**Antelope Springs  
Preliminary/Final Plat and Conditional Use Permit Application  
Recommended Conditions of Approval**

**Antelope Springs**  
**Preliminary/Final Plat and Conditional Use Permit Application Comments**  
March 1, 2013

Quadrant Consulting has been requested by Liz and Kevin Duesman to provide a review of the proposed Antelope Springs Preliminary/Final Plat and Conditional Use Permit applications. The reviewed files were obtained from the Boise City web site on February 15, 2013 (<http://pdsonline.cityofboise.org/pdsonline/details.aspx?id=SUB13-00002&type=doc> and <http://pdsonline.cityofboise.org/pdsonline/details.aspx?id=CUP13-00002&type=doc>). The purpose of this review is to evaluate the proposed project, with respect to potential impacts on the Duesman property.

Figure 1. Vicinity map showing the Antelope Springs and Duesman properties in relation to Harris Ranch. (10/6/2012)

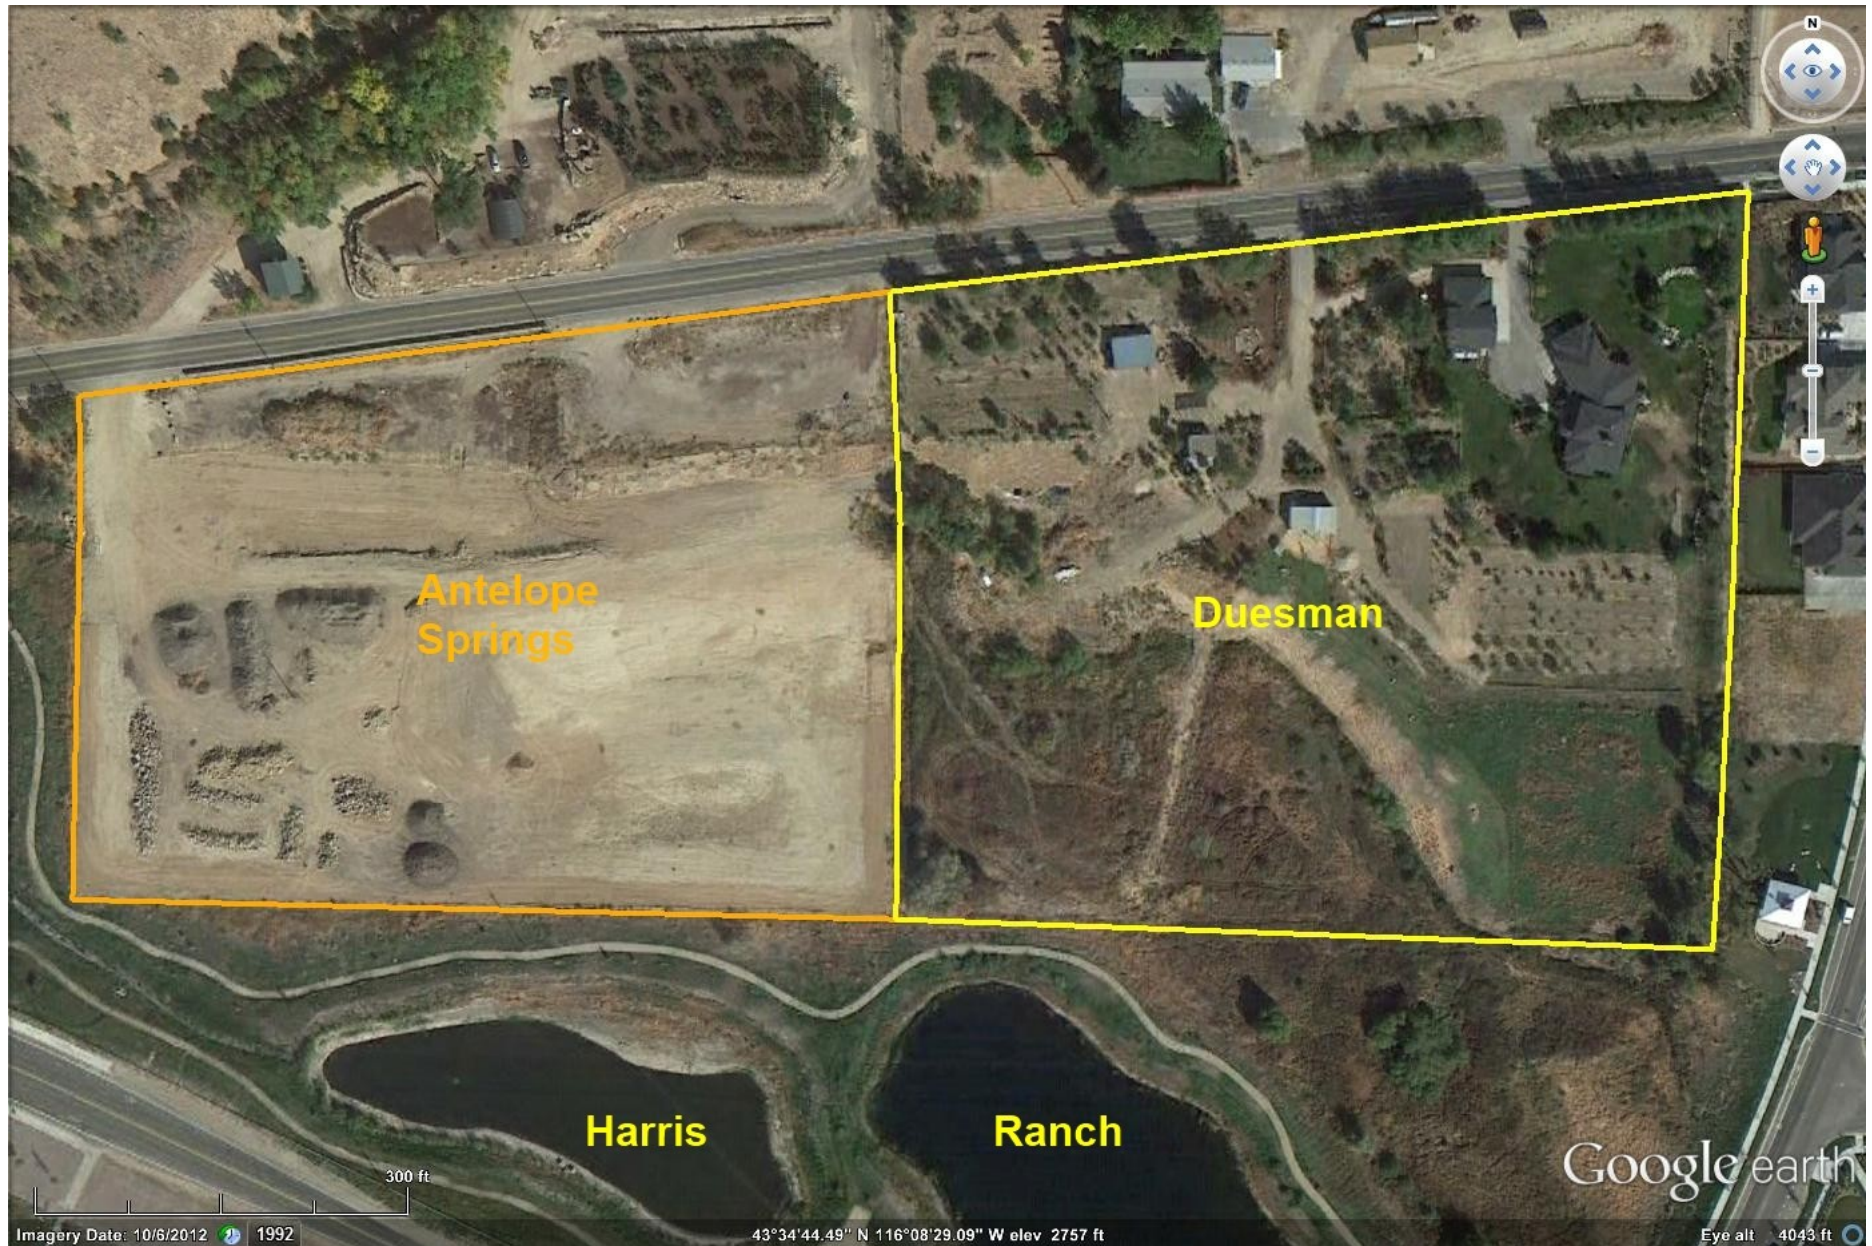
The Duesmans have been neighbors to the proposed Antelope Springs site, since 2004. The two properties share a common border along the west line of the Duesman property. See Figure 1. For reference, the subject site is also immediately adjacent, although outside of, the "Specific Plan District - Harris Ranch, Boise City, Idaho."
